Well Name: SALADO DRAW 19 26 33 FED	Well Location: T26S / R33E / SEC 19 / NENW / 32.03559 / -103.612998	County or Parish/State: LEA / NM
Well Number: 3H	Type of Well: OIL WELL	Allottee or Tribe Name:
Lease Number: NMNM27506	Unit or CA Name:	Unit or CA Number:
US Well Number: 3002542280	Operator: CHEVRON USA INCORPORATED

Notice of Intent

Type of Submission: Notice of Intent	Type of Action: Plug and Abandonment
Date Sundry Submitted: 02/28/2025	Time Sundry Submitted: 06:34
Date proposed operation will begin: 04/07/2025

Permit Procedure Only – Salado Draw 19 26 33 Fed 3H

Proposed WBD

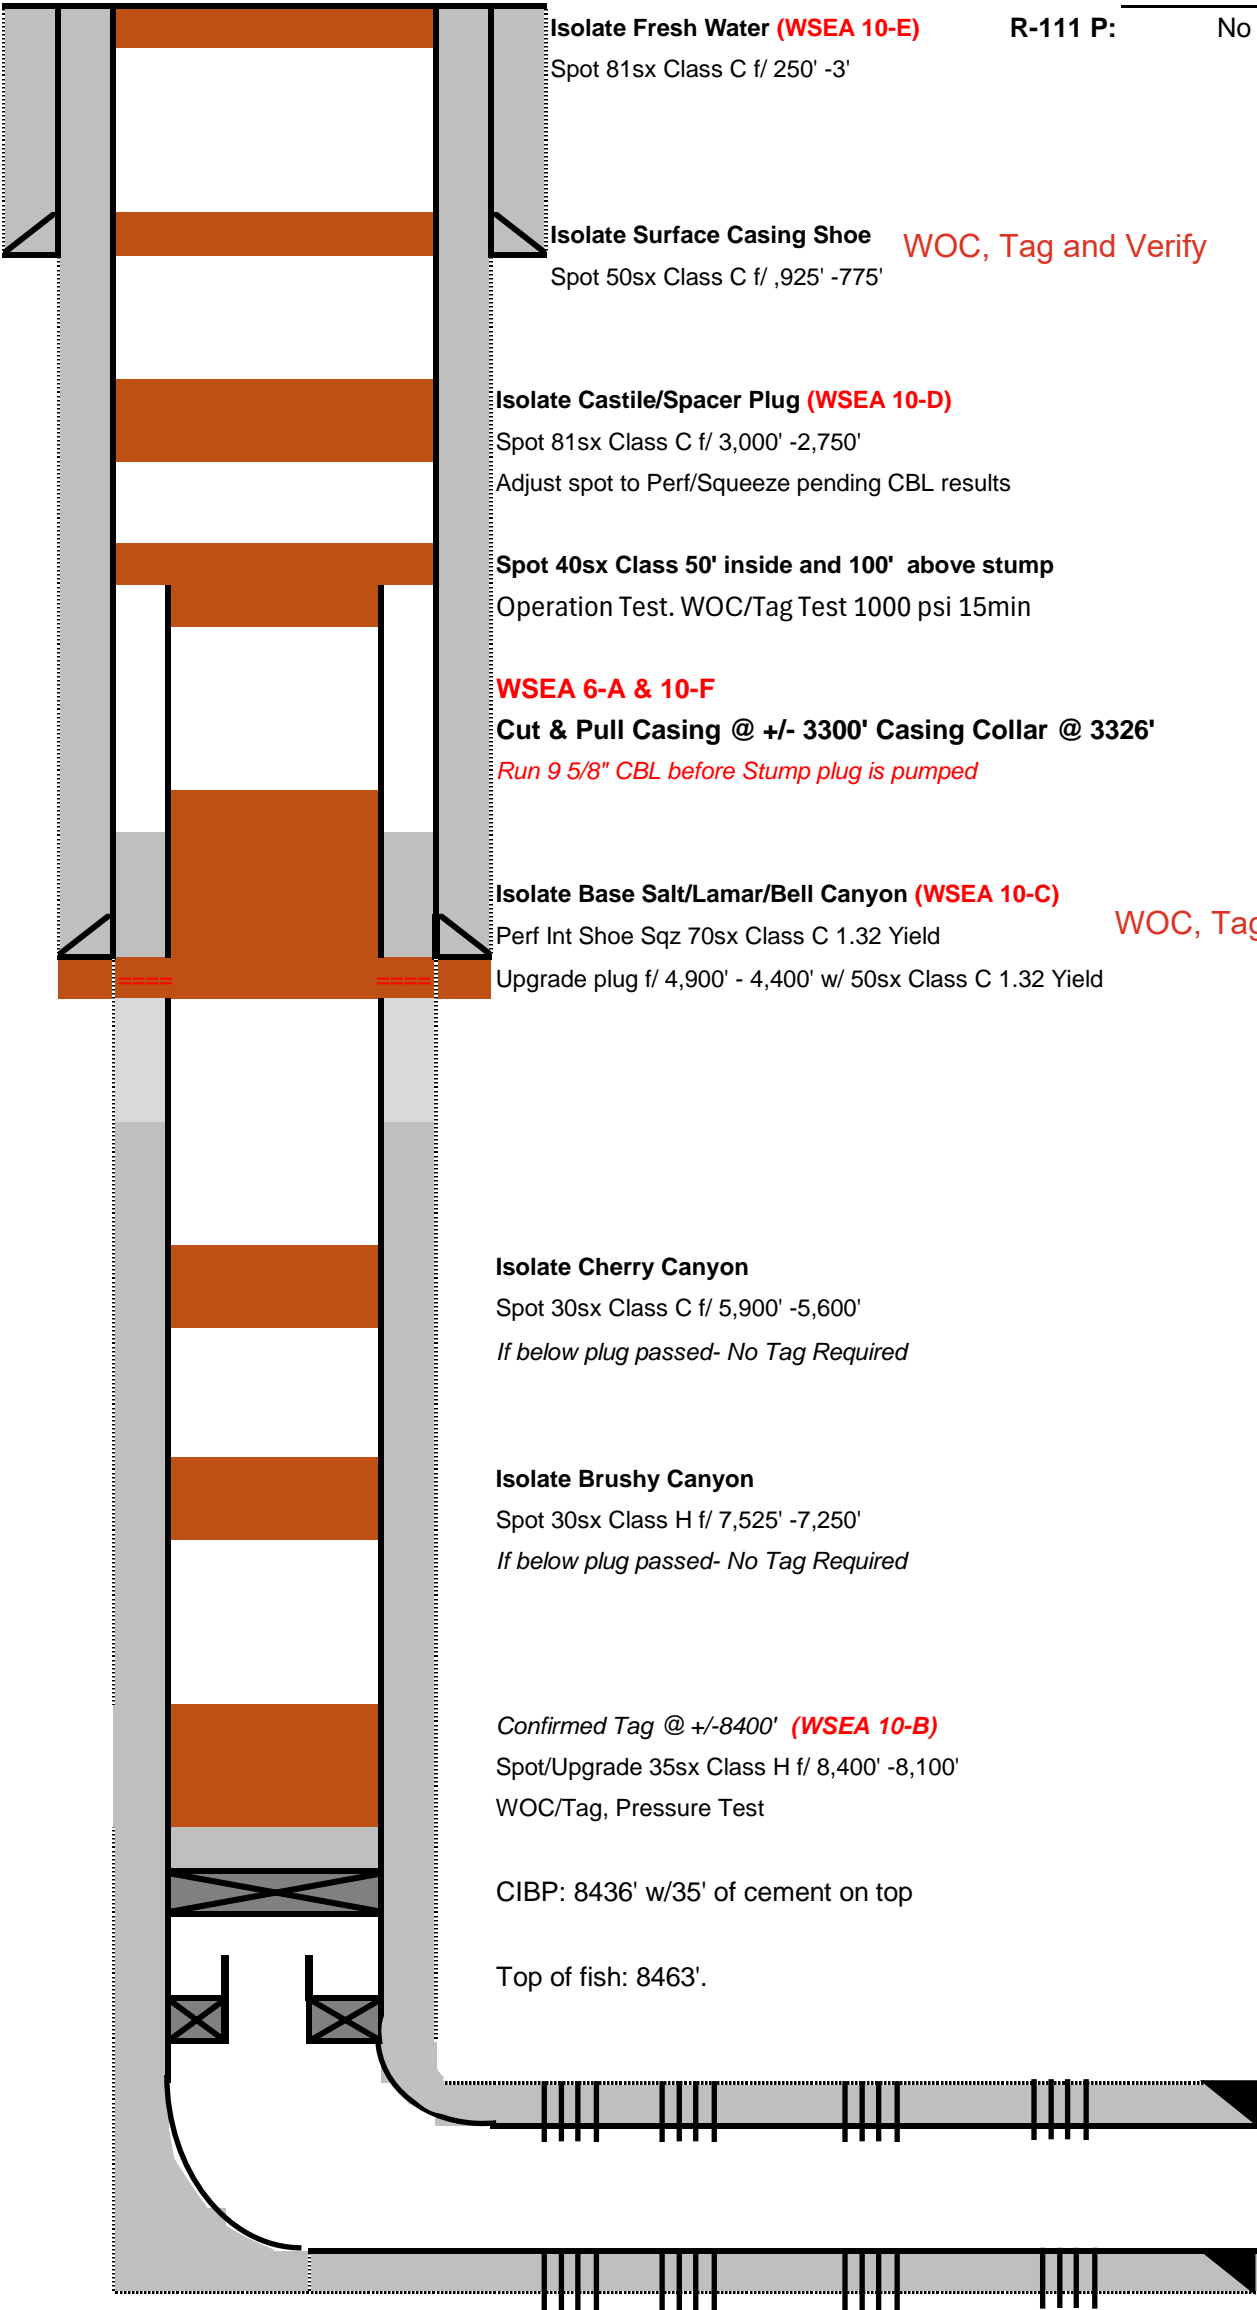
1. MIRU,N/U & Test BOPs
2. Log already when well was TA'd TOC +/-4350' **CBL OK for BLM**
3. RIH w/ Tubing and upgrade +/-8400-8100 w/ 35sx Class H WOC/Tag Pressure Test plug
Leak test CIBP and casing 500psi, 30mins

4. Isolate Brushy Canyon spot 30sx Class H f/ 7525-7250. If step 3 passed - No Tag
5. Isolate Cherry Canyon spot 25sx Class H f/ 5900-5600. If Step 3 passed - No Tag

6. Perf/Sqz Int shoe with 70sx Class C. **Note:** some cement across shoe want to try sqz shoe if we can
 - a. Once shoe sqzd Spot Lamar/Int Shoe/Bell Canyon 50sx Class C f/ 4900-4400. WOC/Tag
Notify BLM if sqz attempt pressures up

7. Bubble Test all annuli. Report back to engineer
8. Cut/Pull casing @ 3300'. POH w/ casing-LD
9. Run CBL from top of casing cut to surface. Report back to Engineer and BLM

10. Spot 50' inside stump and 100' above stump. WOC/Tag Test to 1000psi 15min operation test
11. Spot 81sx Castille Plug f/ 3000-2750
 - a. Pending CBL plug may change, Volumes may change if no cement behind casing. Contact engineer

12. Spot surface shoe plug w/ 50sx Class C f/ 925-775. **WOC and Tag shoe plug**
~~No Tag required if an inside plug and casing passed~~
13. Spot Base of Fresh Water 81sx Class C f/ 250'-3
